SUBJECT: COMANCHE PEAK STEAM ELECTRIC STATION (CPSES)
DOCKET NO. 50-445
OPERATING LICENSE NPF-87
LICENSE AMENDMENT REQUEST 90-003, REVISION TO THE
UNIT 1 TECHNICAL SPECIFICATIONS
SECTION 4.8.1.1.2a(4)(b) AND (c)

PROPOSED CPSES UNIT 1 TECHNICAL SPECIFICATION CHANGES
DIESEL GENERATOR START SIGNALS SURVEILLANCE REQUIREMENTS

FIGURE 940.008.1

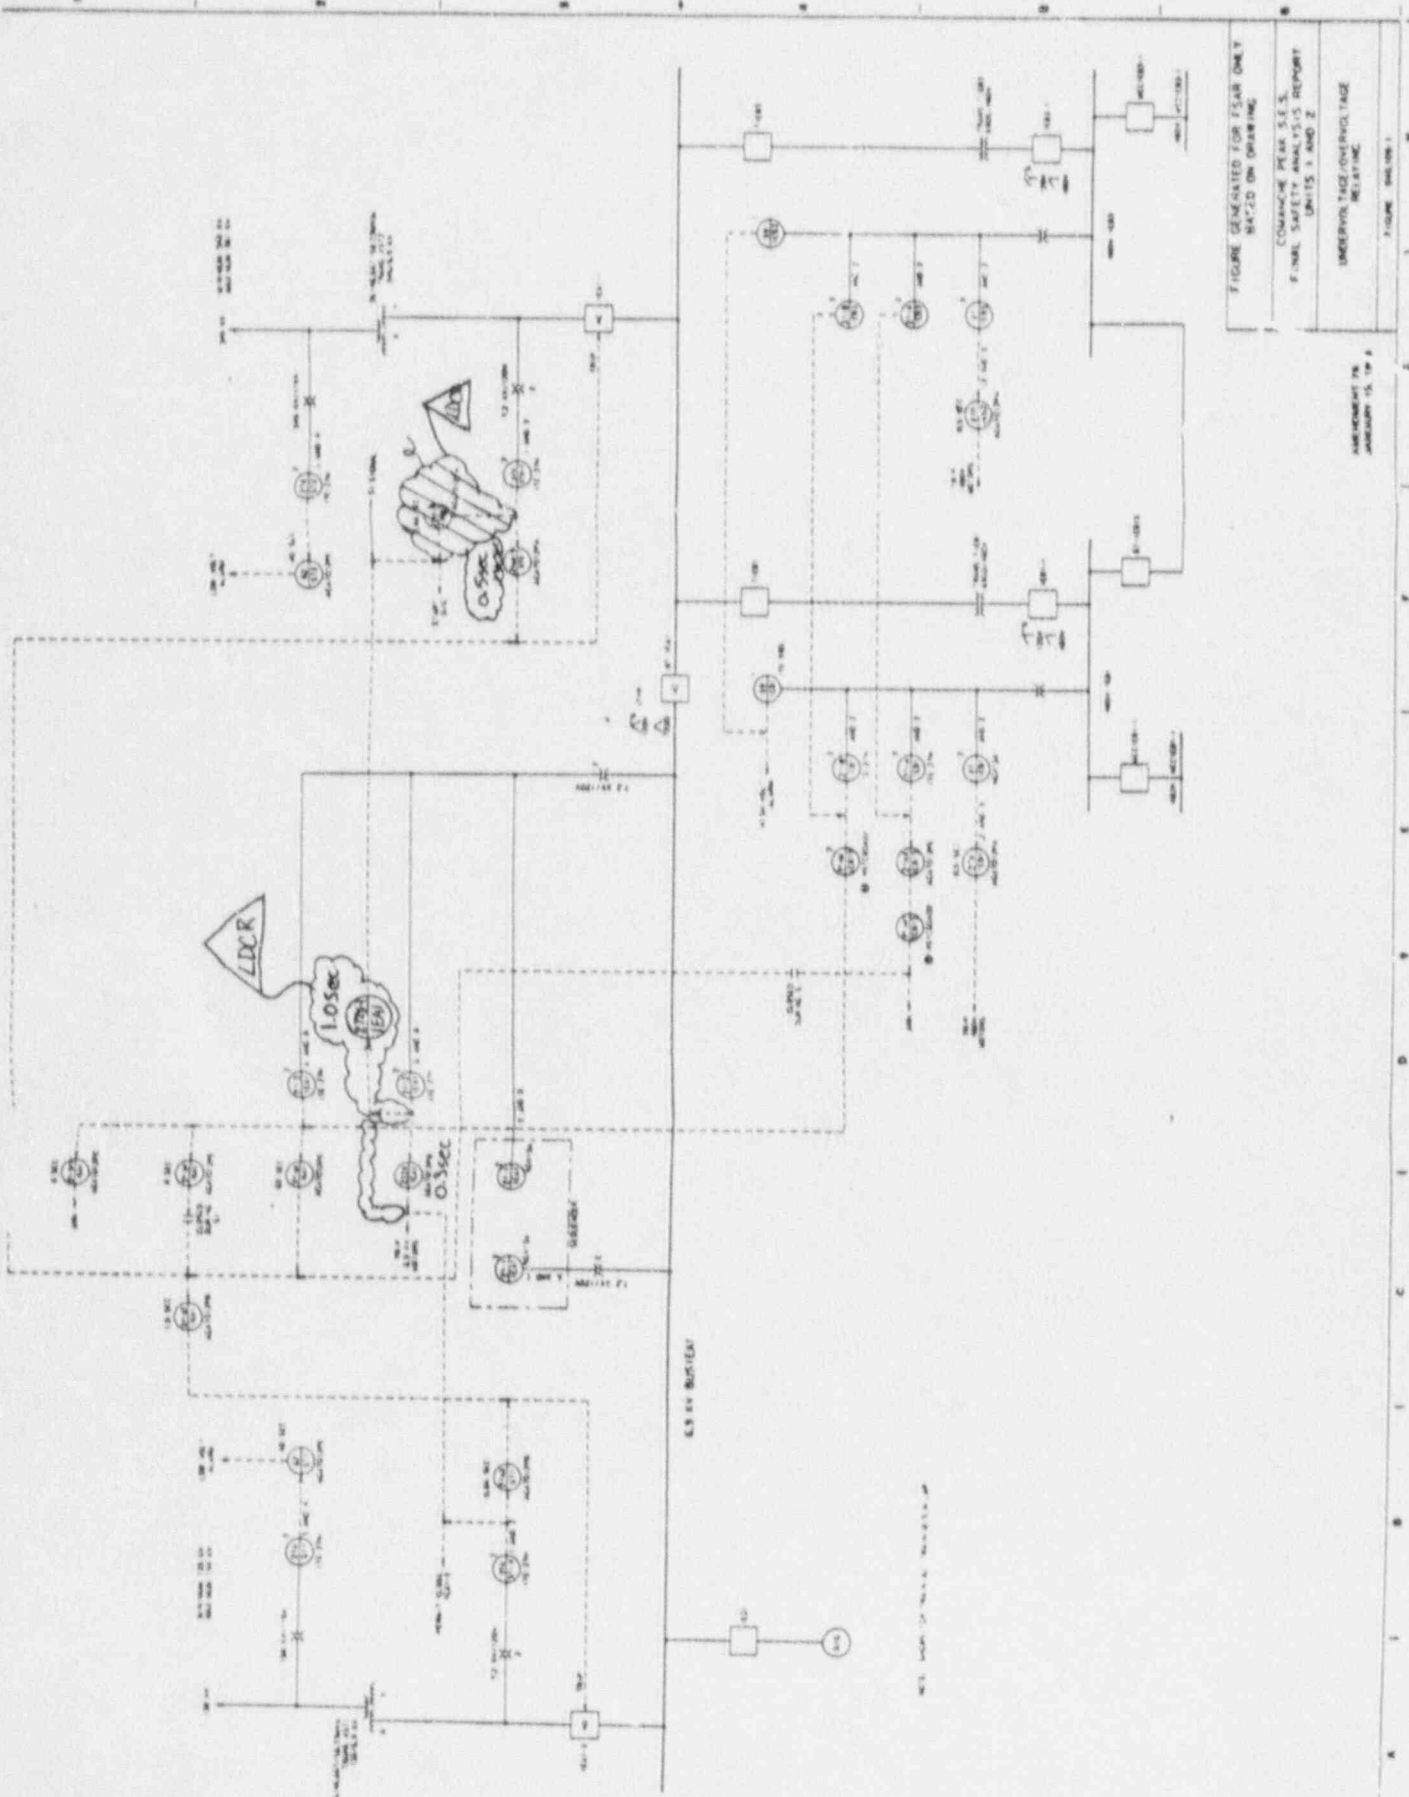
The relay logic that is being modified is shown on Figure 1 (FSAR Figure 040.109-1). The Figure represents the undervoltage/overvoltage relaying for the 6.9kV and 480V Class 1E switchgear. The circuitry modifications being made are contained within 6.9kV switchgear, 1EA1 and 1EA2, and in the sequencers cabinets. The changes consist of:

- 1) removing time delay relays 27AX2/ST2 and 27BX2/ST2 which give the diesels a start signal on loss of the preferred offsite power source;
- 2) removing the start signal from time delay relays 27-2X/1EA1 and 27-2X/1EA2 and adding the start signal to a new time delay relay which is controlled by the bus undervoltage relays 27-2/1EA1 and 27-2/1EA2; and
- 3) changing the time delays for relays 27AX1/ST2, 27BX1/ST2, 27-2X/1EA1, 27-2X/1EA2, and sequencer time delay relay TD/PU.

Figure 2

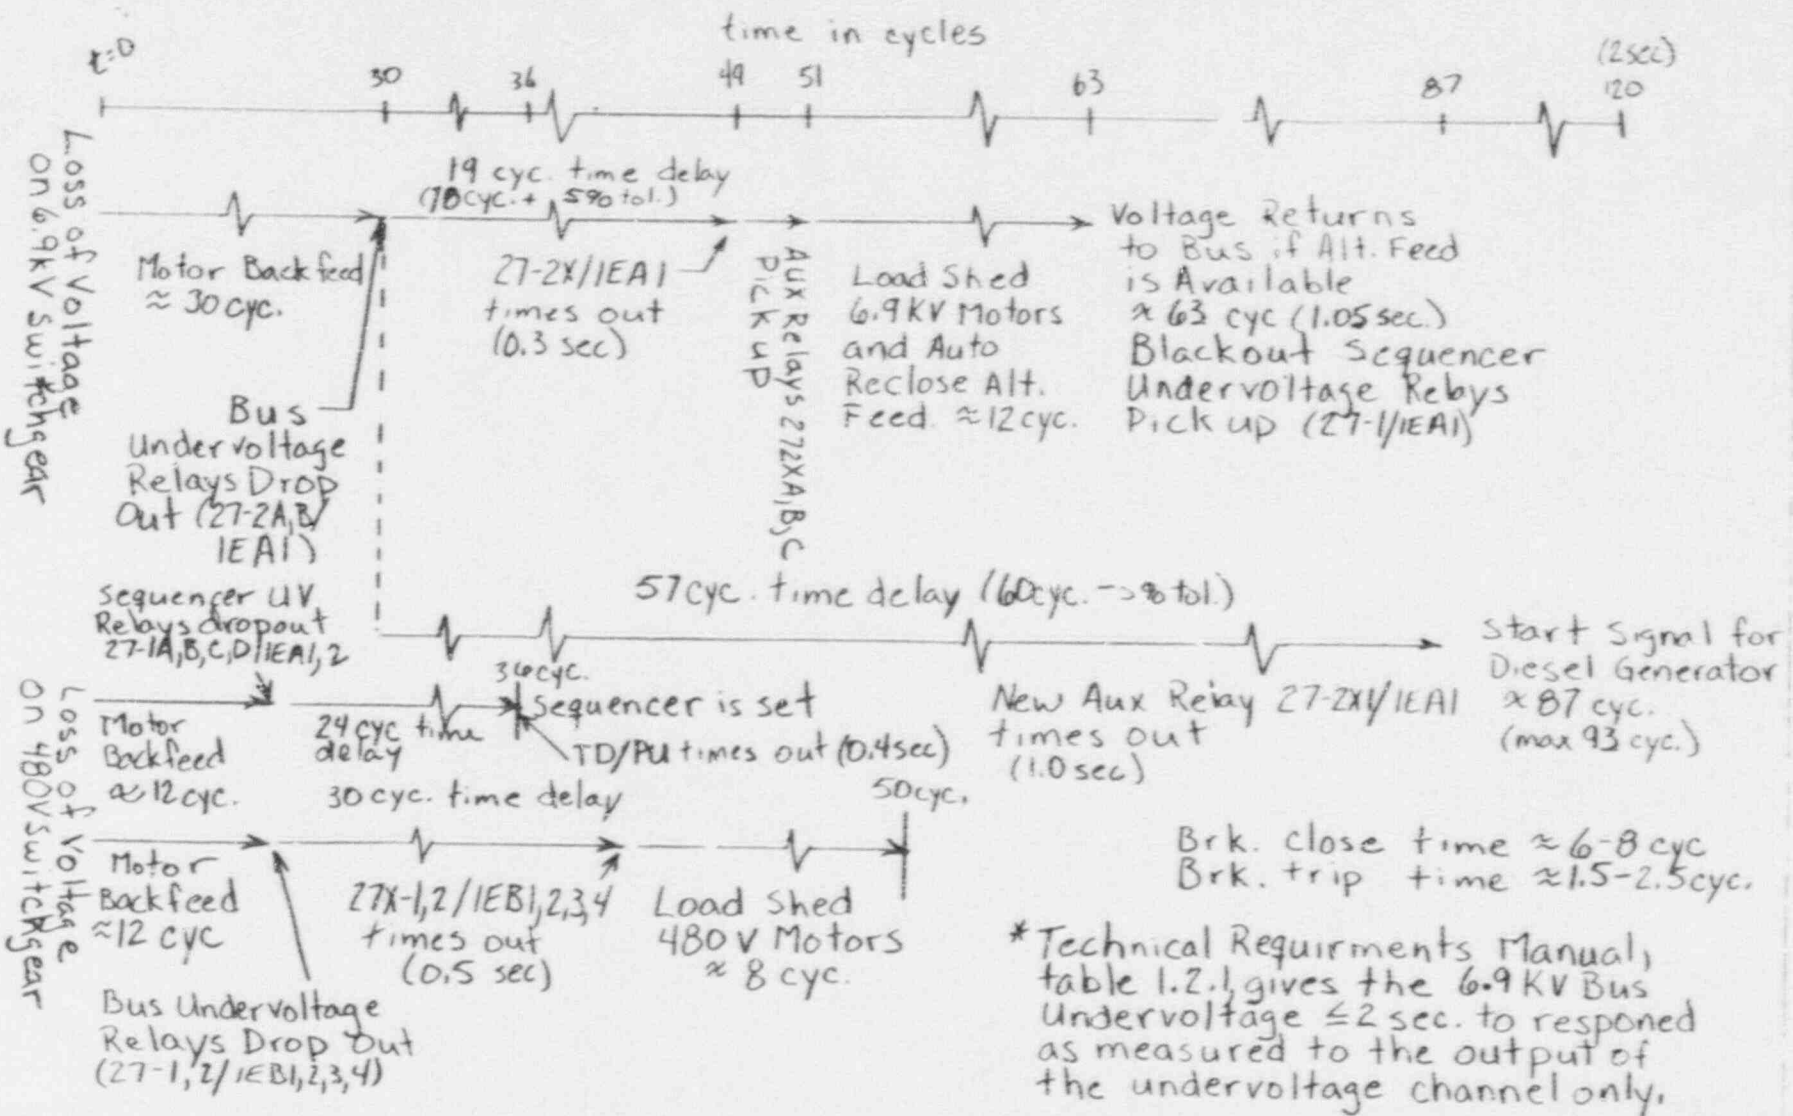
The existing time delay relays (27-2X/1EA1 and 27-2X/1EA2) will have a time delay of 0.3 seconds, activate three auxiliary relays that load sheds all motors on the 6.9kV switchgear and gives the alternate source breaker a permissive to close. The total time duration for the alternate offsite source to return power to the 6.9kV switchgear is approximately 1.05 seconds after the loss of the preferred offsite source (see attached time line in Figure 2).

The other time delay relays that are activated by the bus undervoltage relays will be new relays (27-2X1/1EA1 and 27-2X1/1EA2) that will send a start signal to the diesel generators if the alternate source does not return power to the switchgear. The time delay chosen for the relays is 1 second. With this time delay, the diesels would receive a start signal in approximately 1.55 seconds. The margin to the 2 second Technical Requirements Manual specification is about 0.45 seconds. All other time delay relays (i.e., those which enable the blackout sequencer and shed the motors on the 480V switchgear) time out before the alternate source re-energizes the 6.9kV switchgear.
